City of **HOBART**

APPLICATION UNDER SULLIVANS COVE PLANNING SCHEME 1997

Type of Report: Committee
Committee: 4 July 2022
Expiry Date: 25 July 2022
Application No: PLN-21-455
Address: 6 MONTPELIER RETREAT , BATTERY POINT
8 MONTPELIER RETREAT , BATTERY POINT
ADJACENT ROAD RESERVE
Applicant: Evan Boardman (e3planning Pty Ltd)
PO Box 58
Proposal: Partial Demolition, Alterations, Partial Change of Use to Car Parking, and
Associated Works
Representations: Two (2)
Performance criteria: Activity Area Controls (Use); Traffic, Access and Parking Schedule;
Demolition Schedule; Environmental Management Schedule

Fig. 2. Proposed floor plan. Source: Application documents.

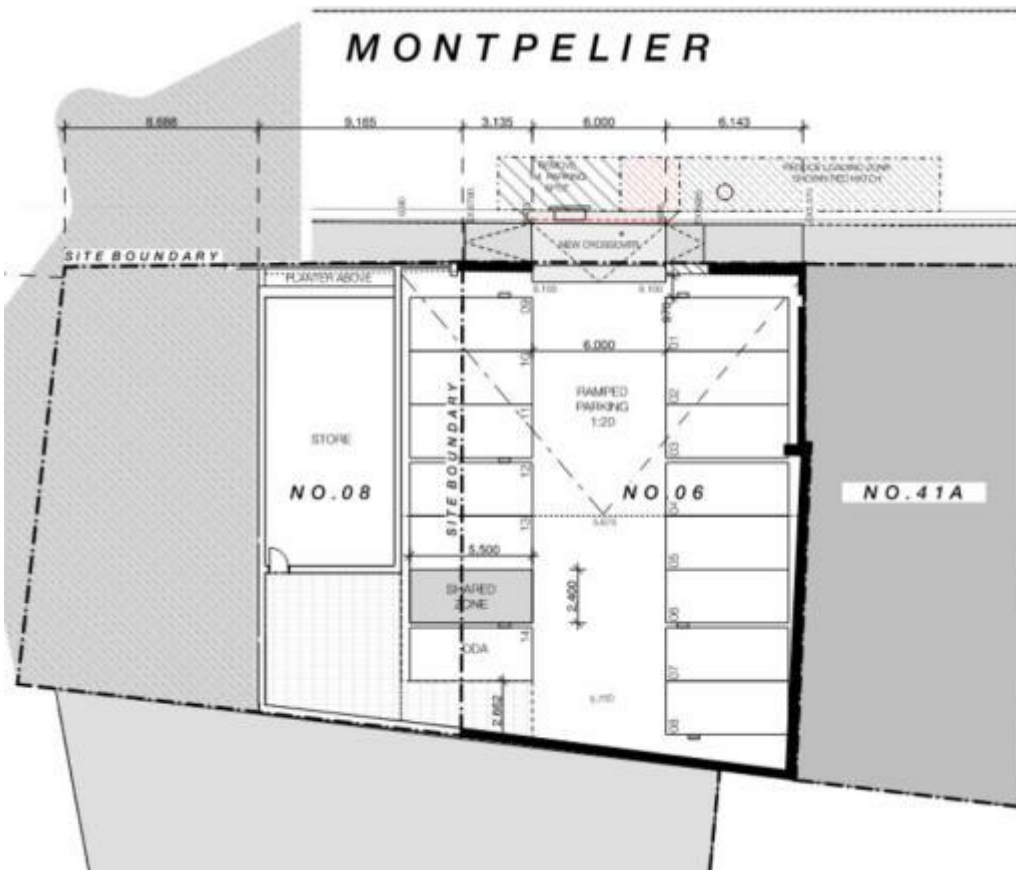
Vehicular sight distance appears to be achievable for the new vehicular access in accordance with AS/NZS 2890.1:2004 however pedestrian sight distances do not comply with AS/NZS 2890.1:2004 due to obstructions such as the wall of the structure located within the pedestrian sight triangle. The TIA has misrepresented the location of the pedestrian sight triangle indicating compliance with AS/NZS 2890.1:2004 however the correct location of the pedestrian sight triangle shows that it does not comply with the Australian Standard and is to be assessed against performance criteria. Conditioning the provision of a speed hump at the exit to the carparking area and pedestrian warning devices will be acceptable for the performance criteria with regard to the proposed pedestrian sight distances.

The car parking area is proposed to be utilised by visitors to Salamanca and used for short term parking. The dimensions of the car parking spaces are proposed to be 2.4 metres wide by 5.5 metres long with a 6.0m wide aisle width. Figure 2.2 of AS/NZS 2890.1:2004 provides car parking space and aisle way dimensions for different user classes. The user class for short term parking is class 3 which would required dimensions of the car parking spaces to be 2.6 metres wide by 5.4 metres long with a 5.8 metre wide aisle way. The user class for employee and commuter parking is

Fig. 3. Proposed elevation plans. Source: Application documents.

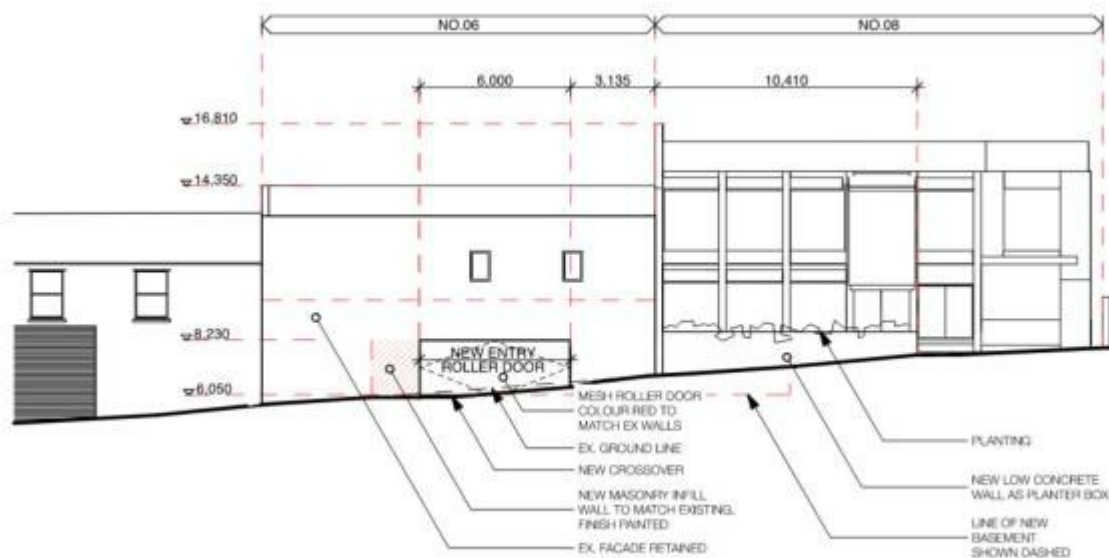
The submitted drawings do not accurately represent the existing facade as there are two windows either side of the central door that are not shown. A new drawing was submitted to demonstrate that the existing windows are proposed to be removed and filled in, the facade rendered to paint as existing.

Schedule 7 - Demolition also applies. While the building is not heritage listed in Schedule 1, Table 1. the revised drawing shows that the elevation will be blank and lacking the features of facades within Sullivans Cove of solid to void, ground floor apertures and features that represent and respect the historic character of the Cove, respecting the scale of the Cove and to enhance the pedestrian experience in the Cove. As such the resultant demolition will result in the loss of an element that contributes to the scale, pedestrian experience of the Cove, by removing apertures that provide scale and pedestrian interest. While it is not expected that the proposed use - a carpark - should retain windows the guiding principles of the Scheme requires consideration of the above factors. As such it is considered a condition be imposed to reduce

The submitted demolition plan indicates an area of approximately 173m² would be excavated. No plans specifying excavation depths has been submitted, however the submitted elevation shows the 'line of new basement'. Assuming this represents the lower extent of

The proposed flush masonry infill that is designed to match the existing facade, after the demolition of the ground floor windows, is not approved. A revised drawing is required to be submitted showing a change in surface treatment at ground level.

The facade at ground level should offer visual interest, provide a change in surface treatment and reduce the solidity and scale of the blank facade with either recessed

blank and solid detailing or a change in material. The pattern of treatment should reflect the scale and proportions of apertures of adjacent heritage buildings. For further advice contact Council's Senior Cultural Heritage Officer on 6238 2175 or email waights@hobartcity.com.au.

Fig. 4. Proposed work in the road reserve. Source: Application documents.

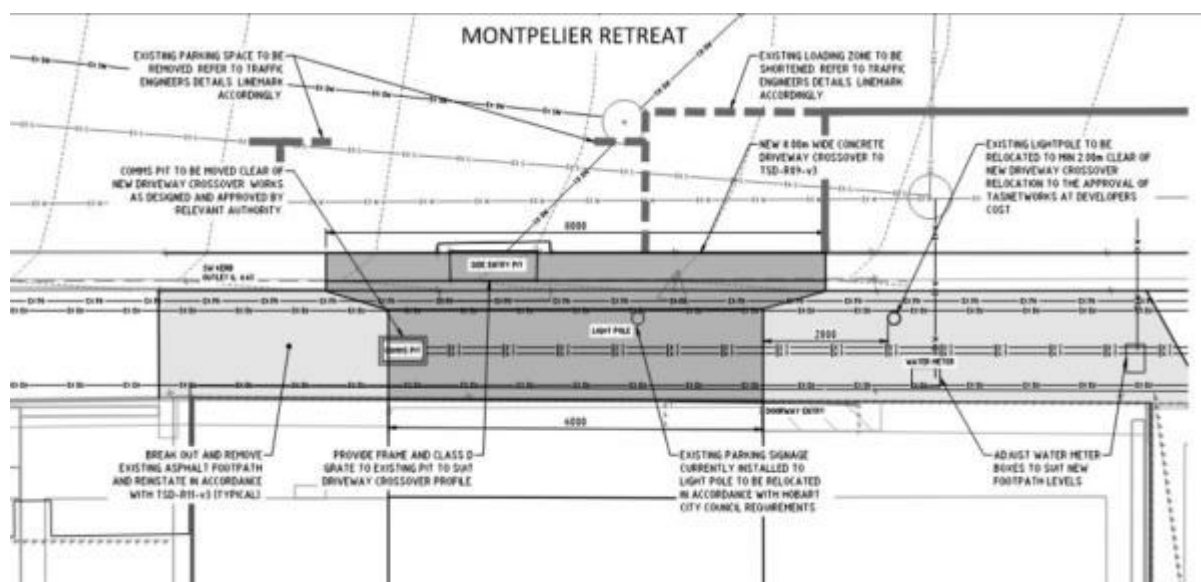
A new vehicular driveway crossover access is proposed for vehicles to access from Montpelier Retreat. The access design is to be in accordance with section 3 "Access Facilities to Off-Street Parking Areas and Queuing Areas" of AS/NZS 2890.1:2004 Parking Facilities Part 1: Off-street car parking to meet the acceptable solution.

The gradients of the access crossover do not meet the requirements of AS/NZS 2890.1:2004 and is to be assessed against performance criteria. Compliance with the Tasmanian Standard Drawing TSD-09-v3 or an alternate design that demonstrates that a B85 vehicle can access the site without scraping the underside of the vehicle will meet the requirements of the Council's Roads Engineer and meet the performance criteria. The documentation provided indicates it feasible that a vehicular access can be provided to satisfy the performance criteria, however Council's Roads Engineer has conditioned for a detailed design of the crossover is to be submitted for approval.

1. **Show the cross and long section of the driveway crossover within the highway reservation and onto the property;**
2. **Detail any services or infrastructure (ie light poles, pits, awnings) at or near the proposed driveway crossover;**
3. **Show swept path templates in accordance with AS/NZS 2890.1 2004(B85 or B99 depending on use, design template);**
4. **Show that vehicular and pedestrian sight lines.**
5. **Provide approval from TasNetworks regarding relocation of the light pole.**
6. **Be prepared and certified by a suitable qualified person, to satisfy the above requirements.**
